## **Final Draft PMPU and Final PEIR Additional Late Written Comments**

**San Diego Waterfront Coalition Comments on San Diego Unified Port District final draft Port Master Plan Update and Program Environmental Impact Report**

**EXISTING EMBARCADERO**

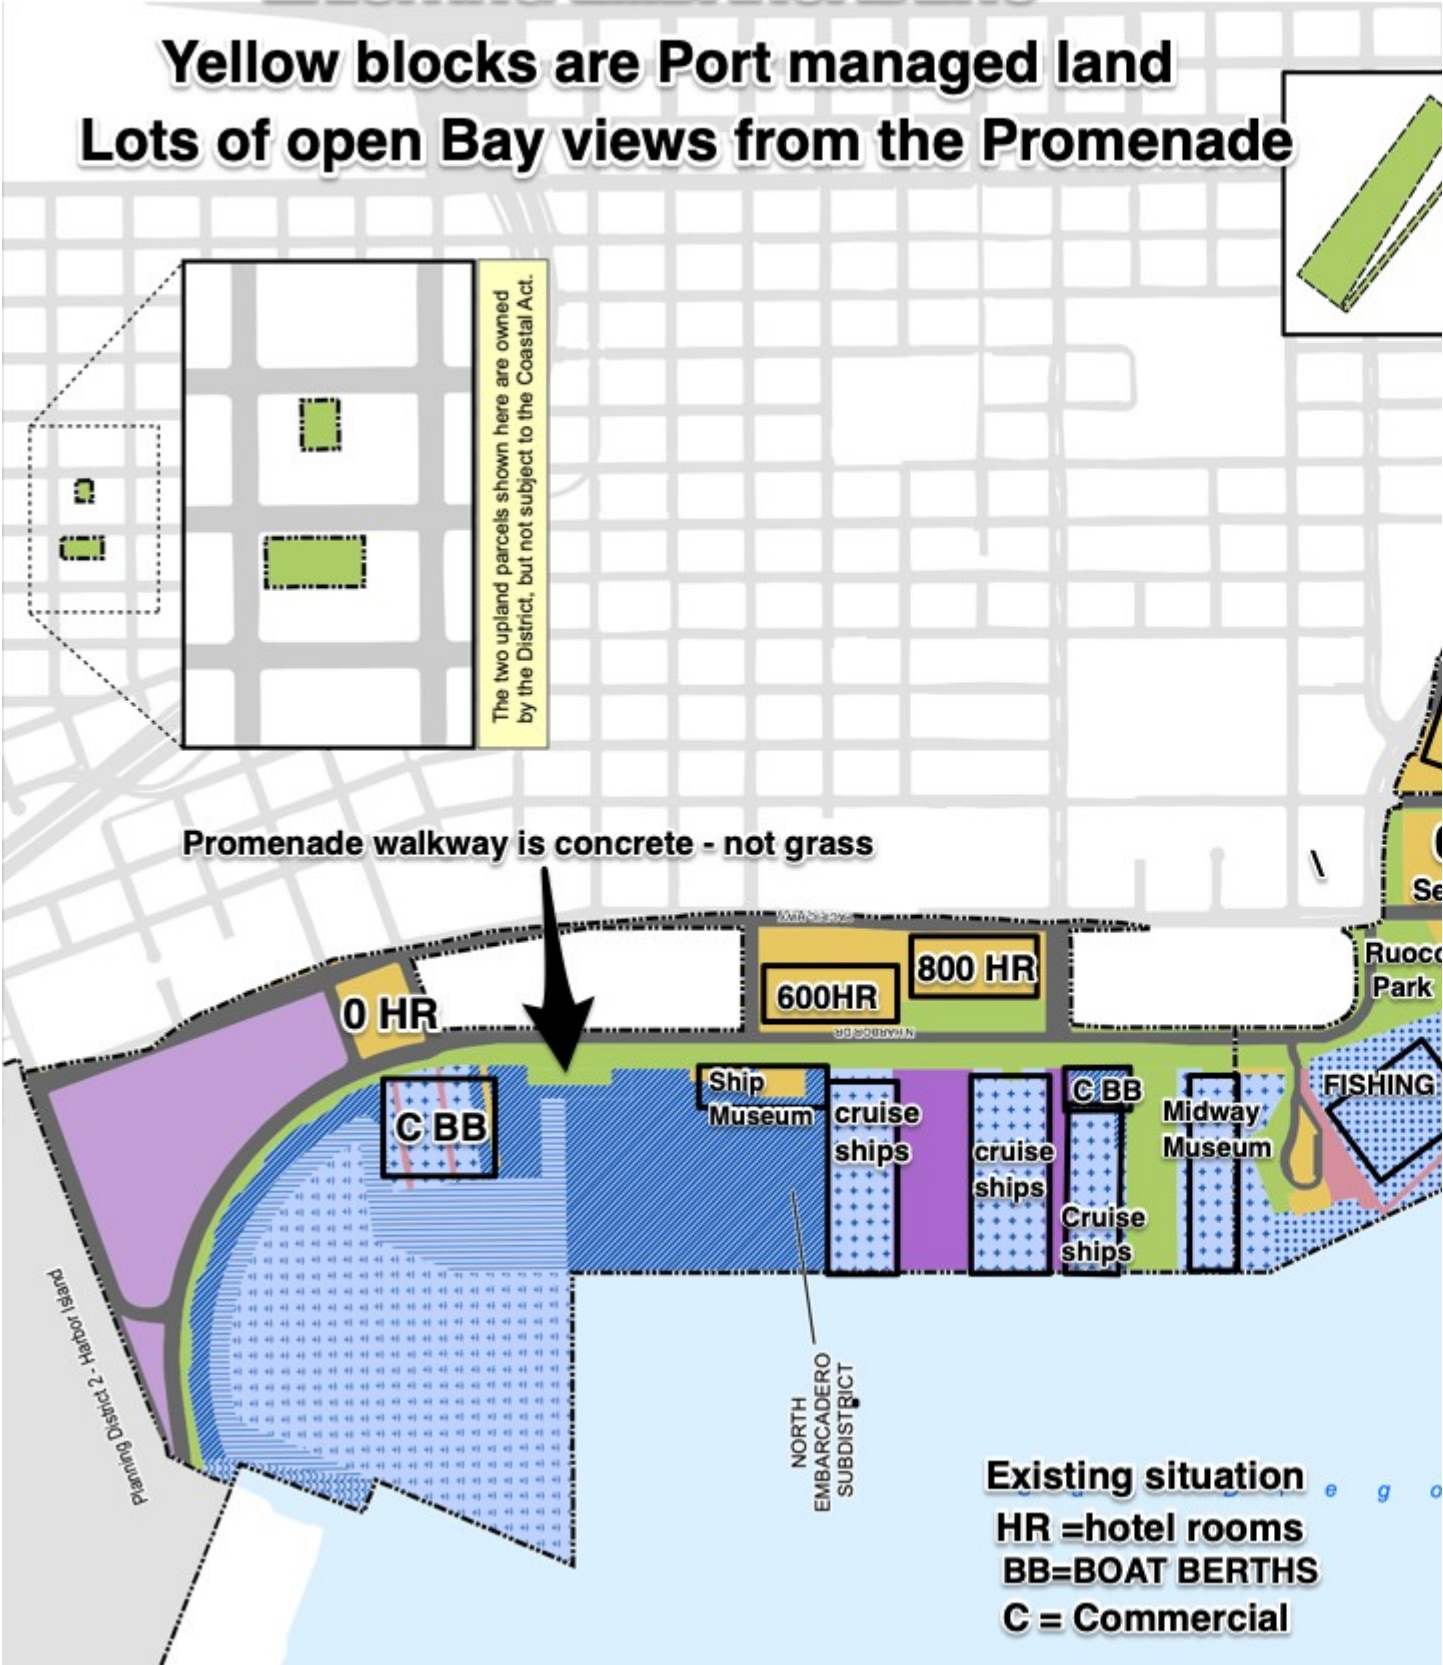
Unless you have really evaluated the whole package, please don't support this horrible impact on downtown. The PEIR is awful.

**Yellow blocks are Port managed land**  
**Lots of open Bay views from the Promenade**

**Figure 4.4**

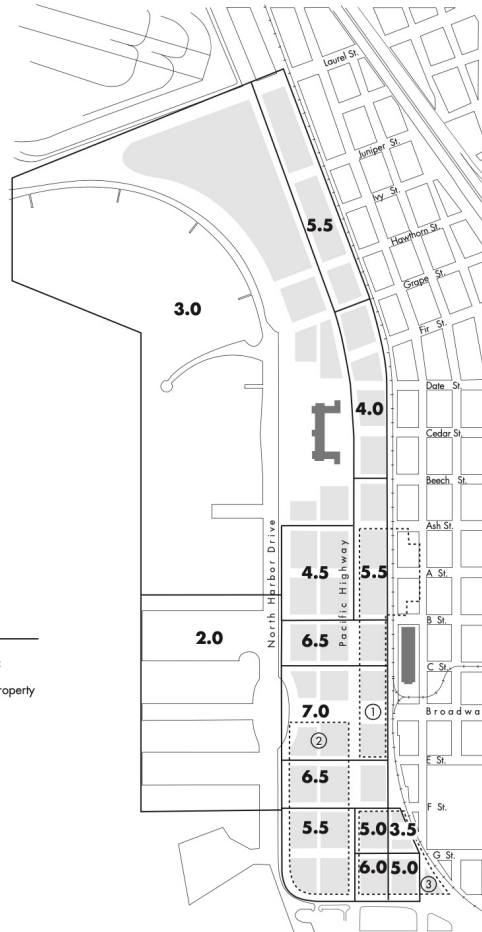
The Blocks labeled A,B C and D in the Figure PD3.8, page 274 of the Draft PMPU or the areas bounded by Pacific Hwy and Harbor Drive and between B Street and Ash, must have Floor Area Ratios of 4.5 added to the plan.

Development density limits, together with other requirements such as height limits, massing limits, and setback requirements, set parameters for the final build-out potential of a site. Consistent with the Centre City Planned District Ordinance and the Marina Plan District Ordinance, Figure 4.4 describes the maximum intensity of development in terms of Floor Area Ratio (FAR). Floor Area Ratio is defined as the ratio of gross floor area to site area. Gross floor area includes on-grade and above-grade parking area. Site area excludes land in rights-of-way. The Intercontinental FAR is 3.8.

FIGURE PD3.4 EMBARCADERO PLANNING DISTRICT - COASTAL ACCESS: VIEWS AND PATHWAYS

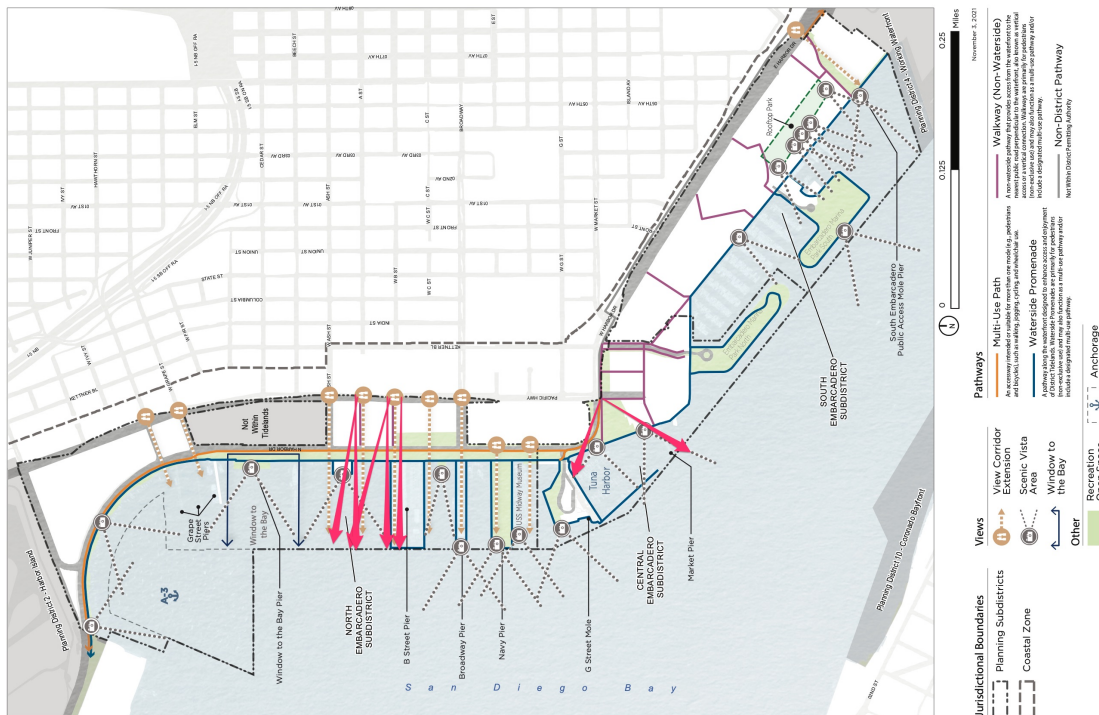
Figure PD3.4 should have an inland Scenic Vista location added at the corner of Pacific Hwy and Harbor Drive to preserve the views created by Ruocco Park

174 Figure PD 3.4 Some coastal views should be from the inland side of the Port property, such as Pacific Hwy, not just down street corridors and the waters edge.

Figure PD3.4 page 261: Although we appreciate all the Access and Scenic Views in the PMPU, we think they are insufficient. There's a level of absurdity when the only views relevant to the Port occur when people are in the middle of the street or are able to see water when they are at the water's edge.

Additional inland view corridors added in red
